**HANNEY & ASSOCIATES ARCHITECTS**  
1726 South Hillside, Wichita, Kansas

**NOTICE TO BIDDERS**

You are hereby instructed to include in your bids the following changes and/or corrections to the Drawings and Specifications for the Gym Addition at Garden Plain High School in Garden Plain, Kansas.

GARDEN PLAIN HIGH SCHOOL - NEW GYM  
ADDENDUM #1

E2.1 ELECTRICAL POWER/SYSTEMS PLAN - BASE BID

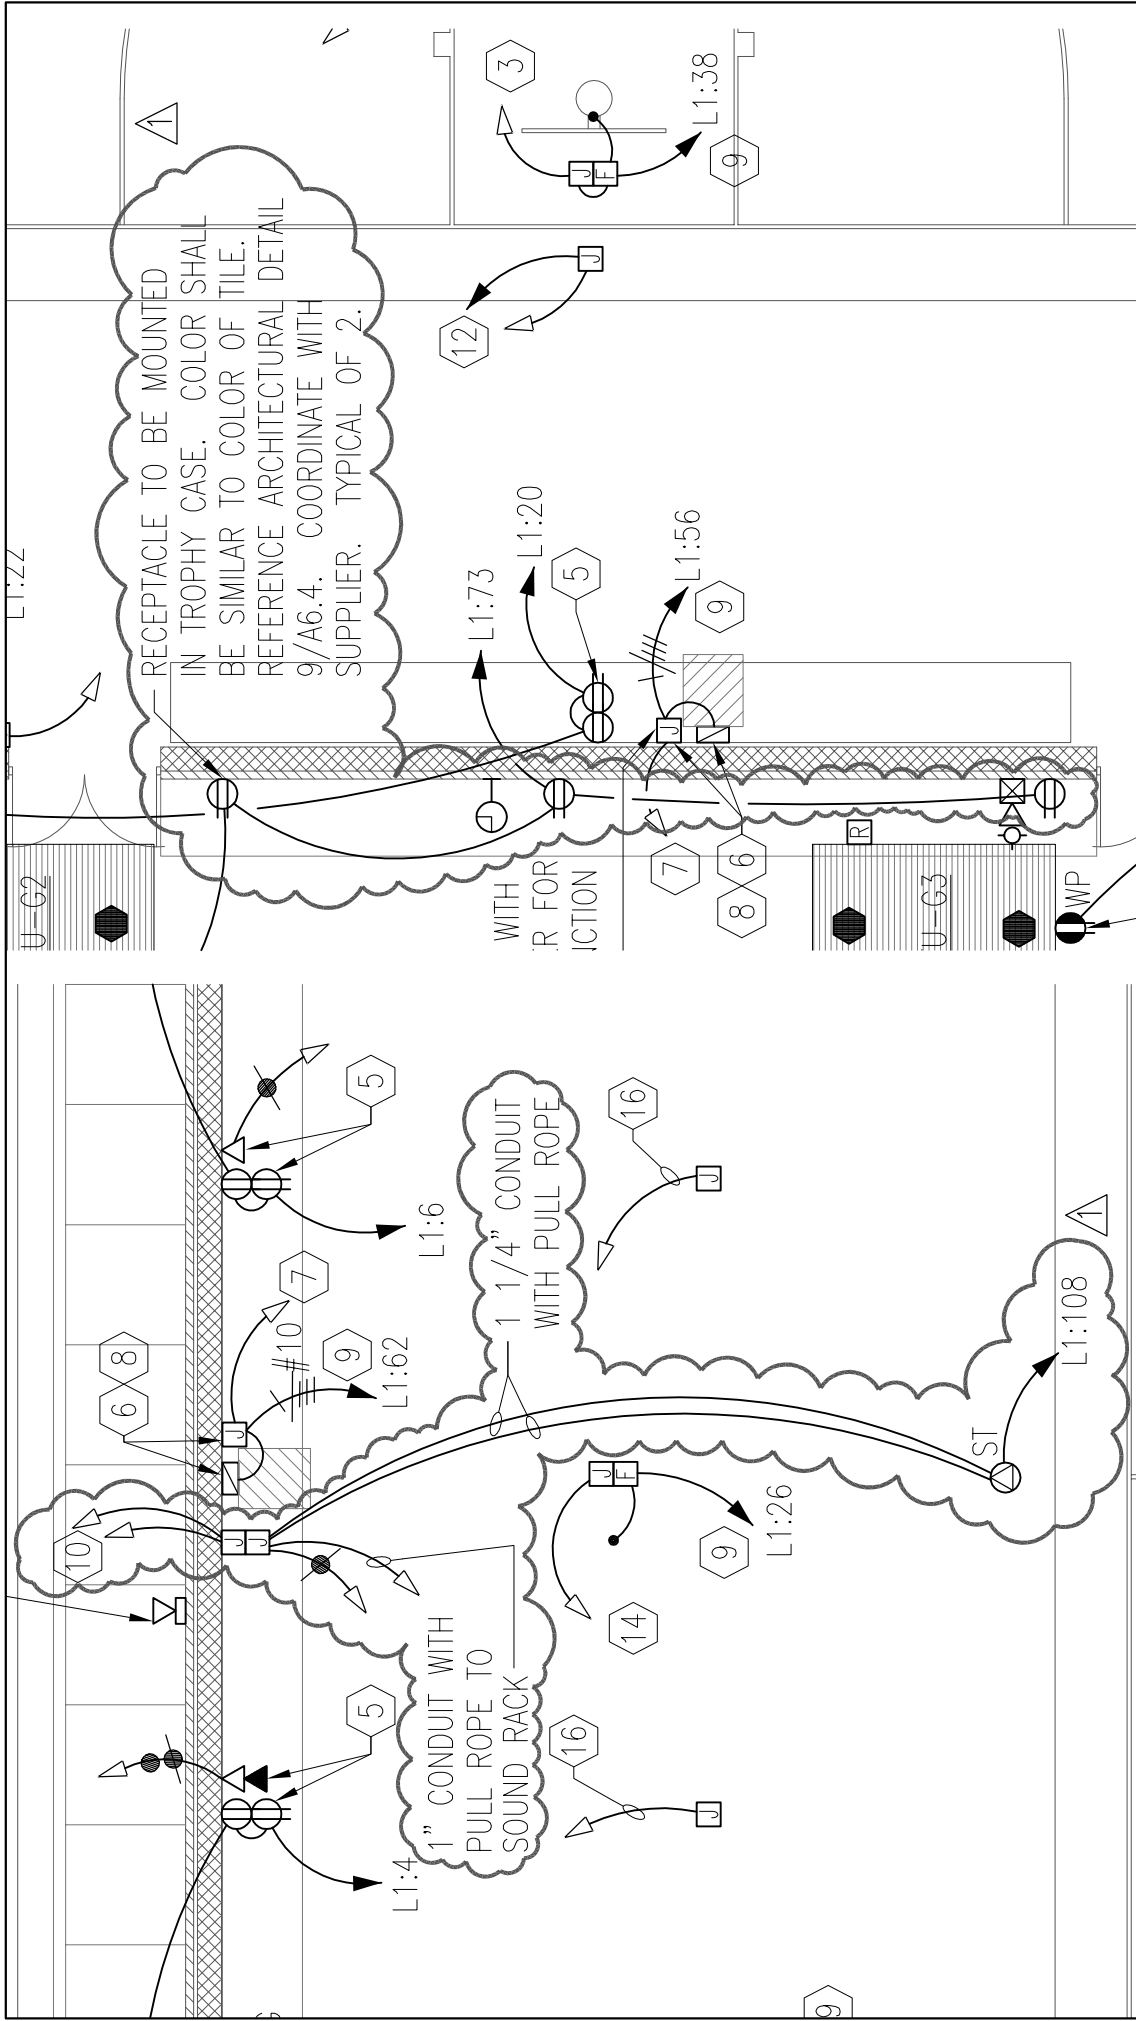
- 4.5 Add special outlet “ST” and associated wiring for gym score table floor box on west side of gym. Reference Sheet E2.1 attached.

- 4.7 Add two receptacles in trophy case per architectural detail. Reference Sheet E2.1 attached.

RECEPTACLE TO BE MOUNTED IN TROPHY CASE. COLOR SHALL BE SIMILAR TO COLOR OF TILE. REFERENCE ARCHITECTURAL DETAIL 9/A6.4. COORDINATE WITH SUPPLIER. TYPICAL OF 2.
